UNITED STATES PATENT AND TRADEMARK OFFICE

APPLICATION NO.	FILING DATE	FIRST NAMED INVENTOR	ATTORNEY DOCKET NO.	CONFIRMATION NO.
10/632,494	08/01/2003	Stuart Frankel	1044-2U	4409

Office Action Summary	Application No. 10/632,494	Applicant(s) FRANKEL, STUART	
	Examiner Kofi A. Schulerbrandt	Art Unit 3632

DETAILED ACTION

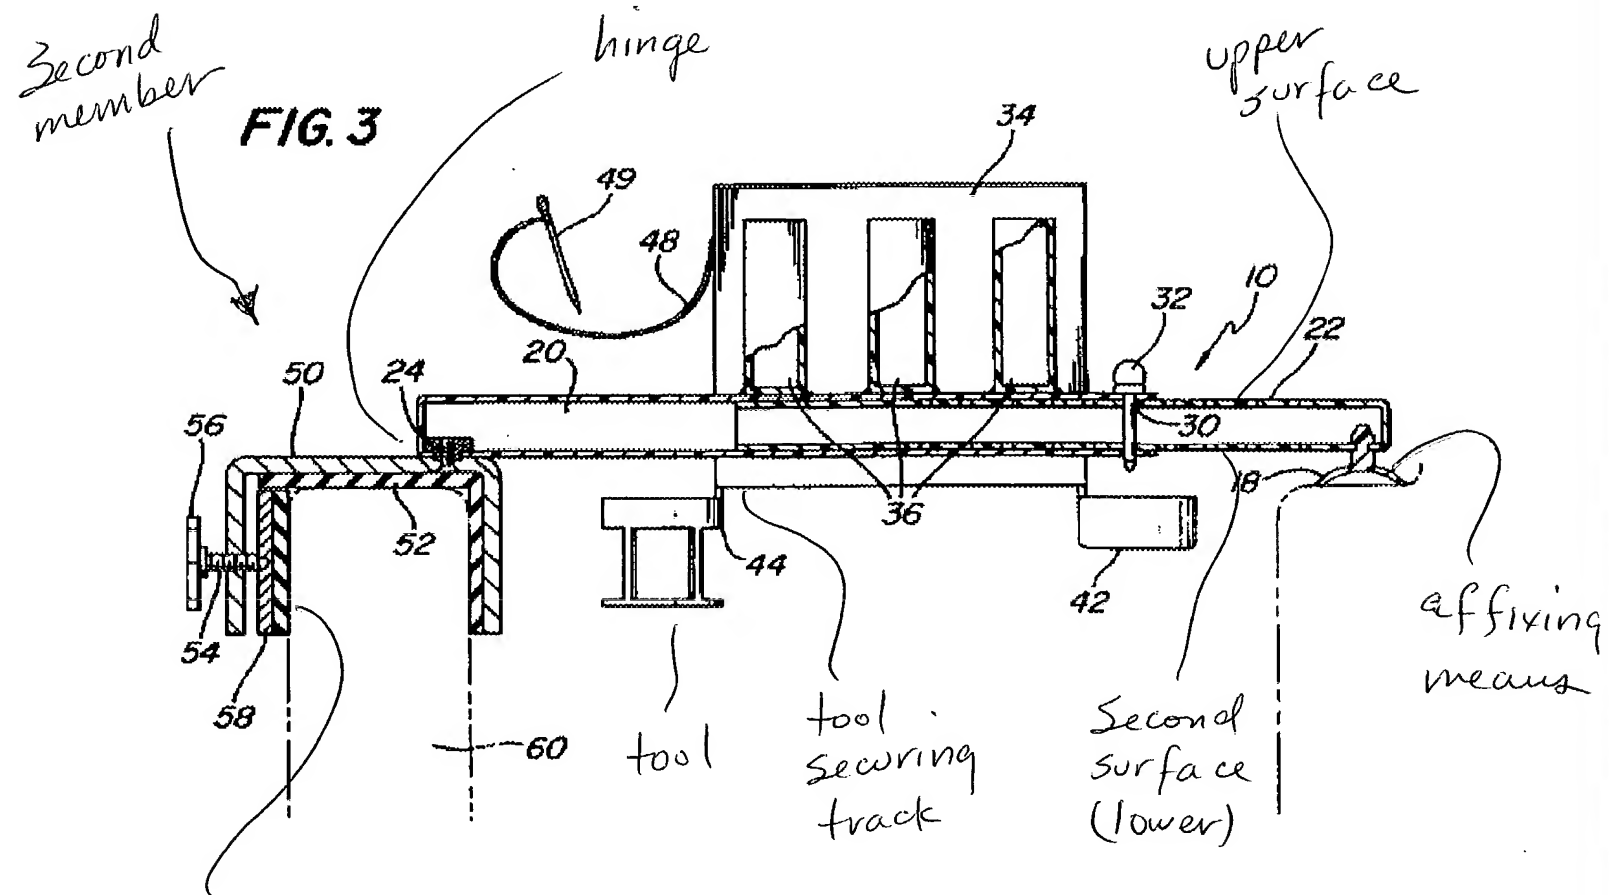
Claims 1, 2, 5-10, 12, 14-17, 19 and 20 rejected under 35 U.S.C. 102(b) as being anticipated by Talbert (5,761,753). Talbert teaches each feature of the claimed invention as shown below.
